VIRGINIA ELECTRIC AND POWER COMPANY
SUBMITTAL OF APPROVED TOPICAL REPORT DOM-NAF-1-REV. 0.0-P-A
QUALIFICATION OF THE STUDSVIK CORE MANAGEMENT SYSTEM REACTOR
PHYSICS METHODS FOR APPLICATION TO NORTH ANNA AND SURRY POWER
STATIONS

**Qualification of the Studsvik
Core Management System
Reactor Physics Methods for
Application to North Anna
and Surry Power Stations**

Appendix A: RAI Set 1 Questions and Responses**NRC Request for Additional Information (first set) and Responses**

Figure 22

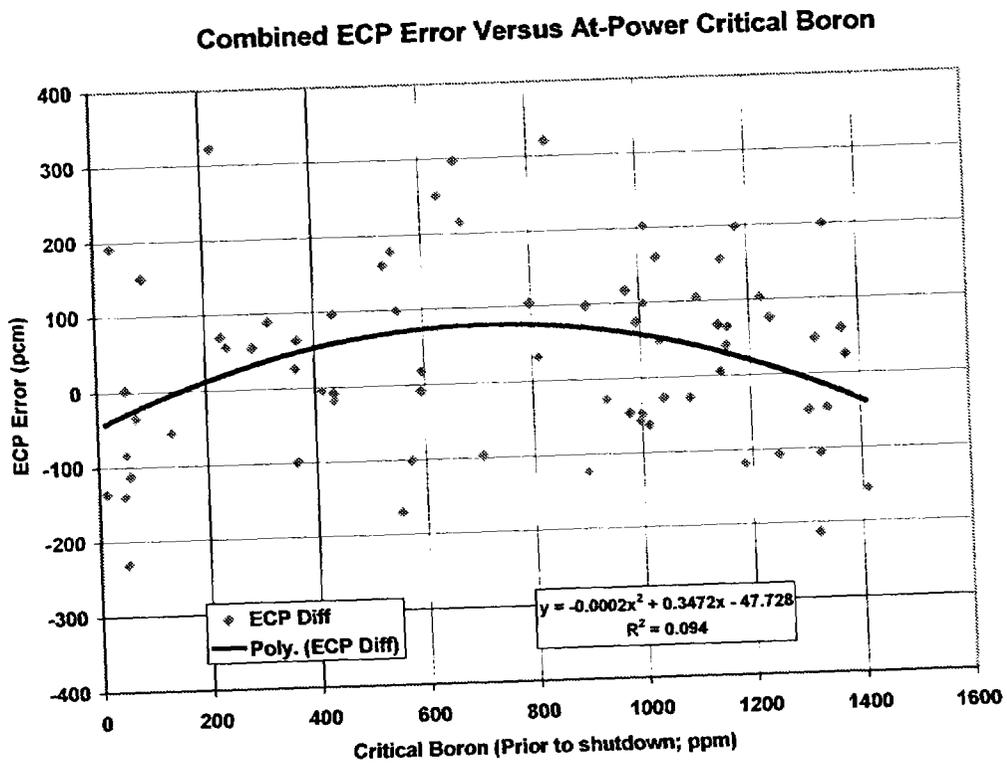
- 7) Figure 22 on page 54 shows significant scatter. Please explain how this data supports your statement that the bias is primarily in the middle of the boron range.

Figure 22 was not intended to demonstrate a strong correlation between boron concentration and ECP error. In fact, no correlation with boron is expected except that which results from the mis-modeling of ECP conditions due to B^{10} depletion. Figure 22 was included to show that a portion of the ECP data scatter is probably due to B^{10} depletion rather than SIMULATE uncertainty. However, for simplicity, all of the data have been included in the determination of the ECP statistics in Table 10.

B^{10} depletion introduces mis-modeling because the measured boron before the ECP can have a different B^{10}/B^{11} ratio than the measured boron at the time of the ECP return to critical. SIMULATE boron predictions are based on a constant B^{10}/B^{11} ratio. The reactivity comparison between measurement and prediction is skewed by the B^{10}/B^{11} difference. Although it is possible to correct for this mismatch, the process involves a great deal of measured data and was not practical due to the large number of cycles modeled.

B^{10} depletion mis-modeling is most likely to occur at mid cycle, during which boron concentration tends to be in the middle of the range shown in Figure 22. The bow in the fit is consistent with the expected influence of uncorrected B^{10} depletion on an ECP. The point in demonstrating this is to show that B^{10} depletion tends to increase the scatter in the ECP data (introduces a positive bias for certain cases but not for others)

Figure 38

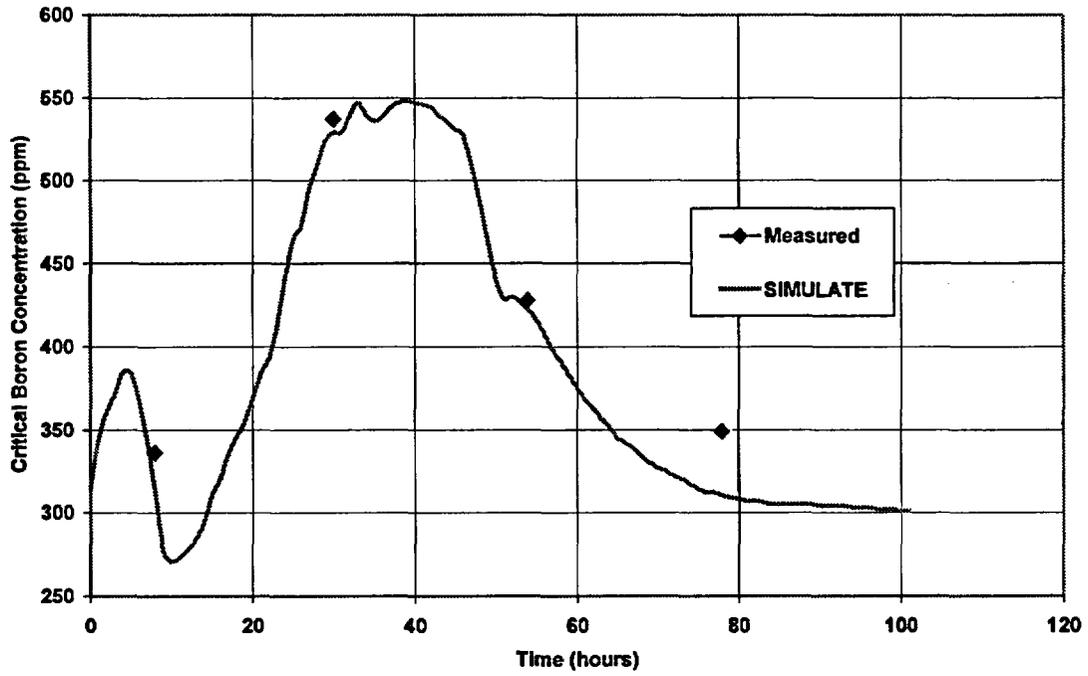
10) On page 75, you indicate that the Figure 38 SIMULATE boron values followed the measured values within about +18/-15 ppm. However, you only provide 4 data points for comparison purposes during the power transient. Describe how SIMULATE accurately models this transient given the limited data. Additionally, describe why the +18/-15 ppm assessment is accurate.

There are only four critical boron data points available for the N1C6 transient. The "+18/-15" comment indicates the range of difference (P-M) for those four points after accounting for the initial difference at the beginning of the transient. These results are consistent with the body of data from the other transients and consistent with the critical boron NRF. The good agreement between predicted and measured delta-I data is the best evidence of modeling accuracy for this transient.
